13 December 1955

SUBJECT : Specification of 9 $\frac{1}{2}$ " Continuous Printer Printing Drum.

Sketch a/s in para 2.

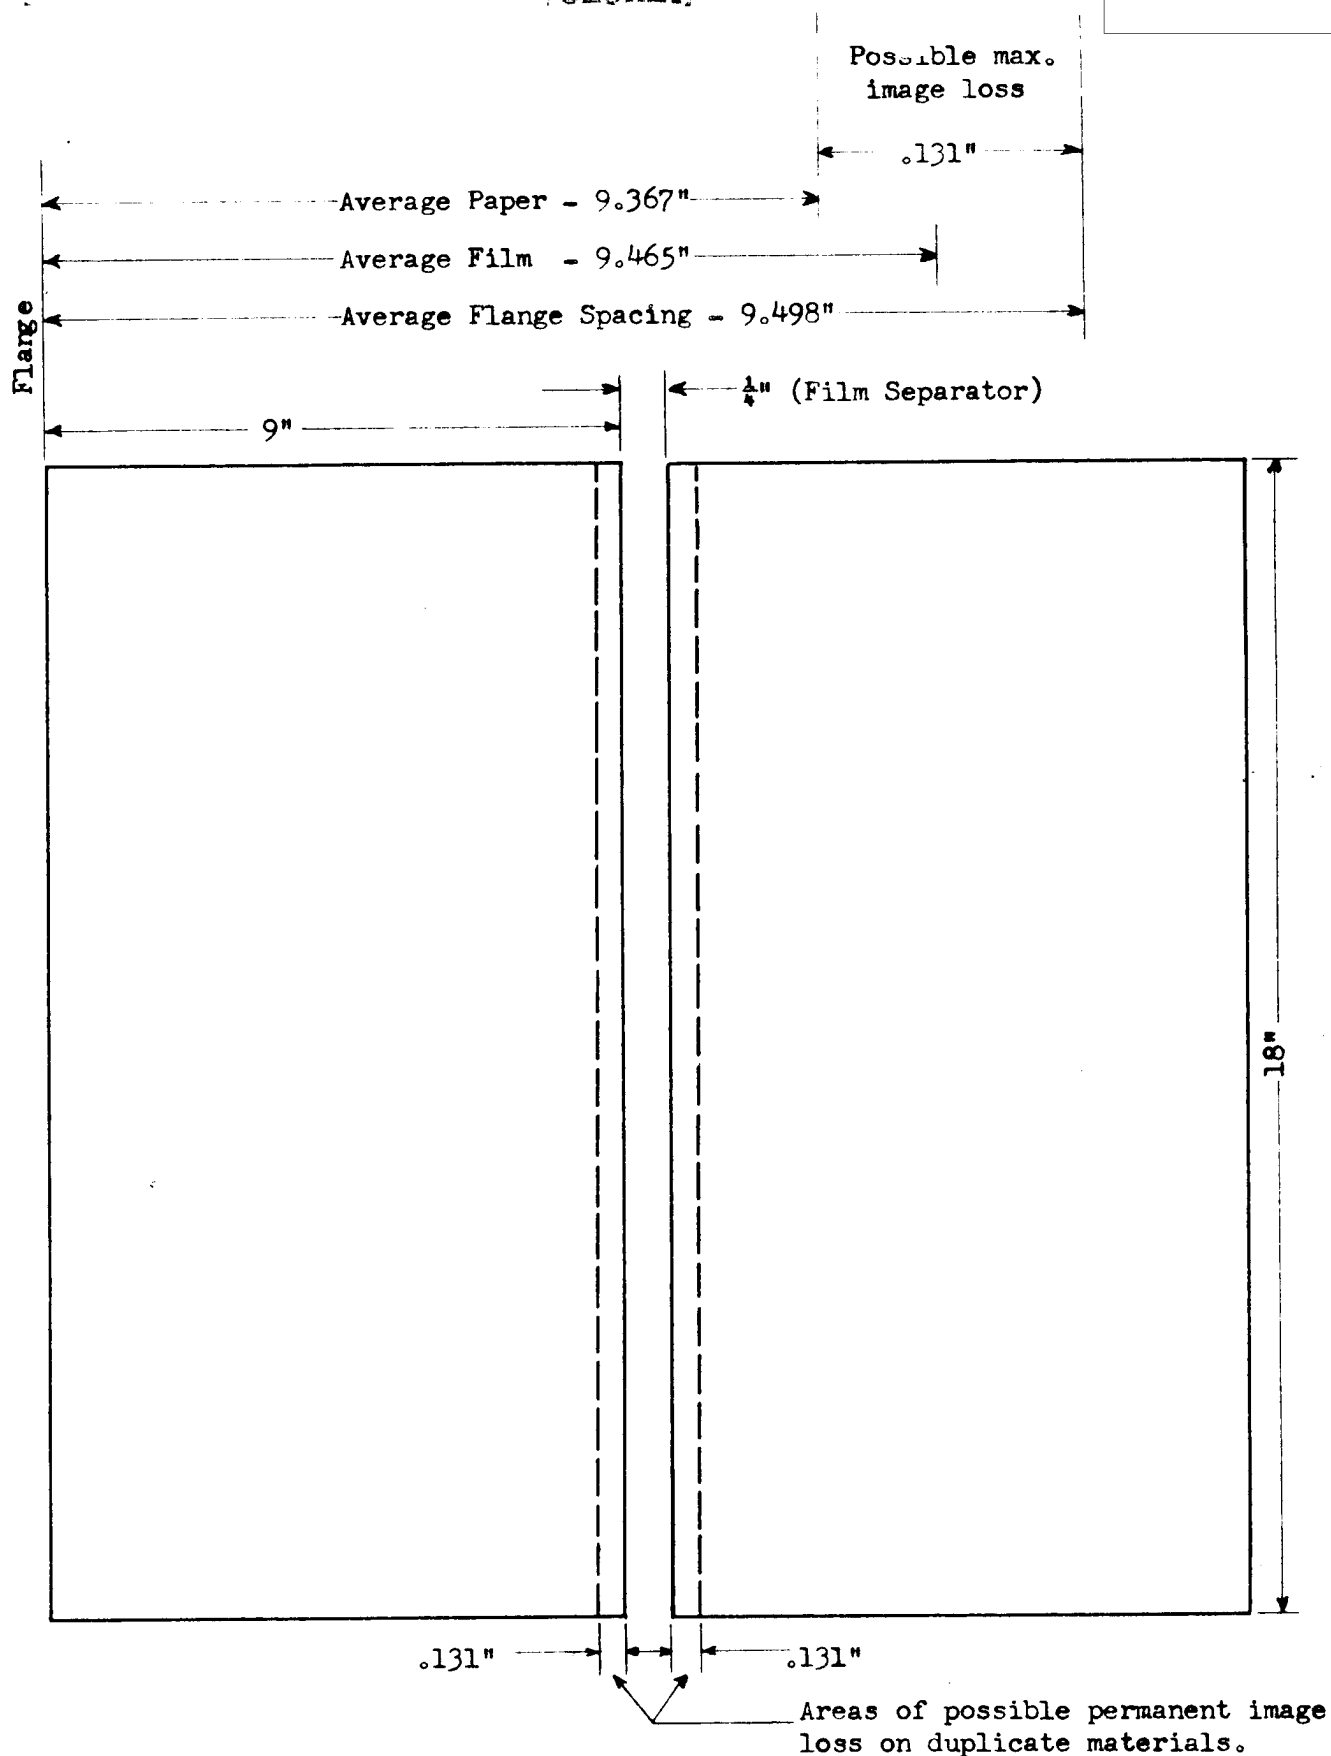
2. The earlier discussions were initiated to determine the feasibility of providing a protective edge on duplicate material from the B and C cameras. This edge is still desirable but the dimensions provided by [] indicate a possible loss of image area in the preparation of duplicate material. The attached sketch indicates the possible loss of image which may occur. The loss of any image area is felt to be very serious and should be prevented if at all possible.

$$\left(\frac{.131}{12}\right) \times 2 \times \frac{70,000}{(36/12)} = 509' = \text{Possible loss of coverage in duplicate materials.}$$

3. It is recommended that Eastman Kodak be contacted to determine the feasibility of altering the printing equipment so as to insure the retention of all image area of the negatives from the B and C configurations.
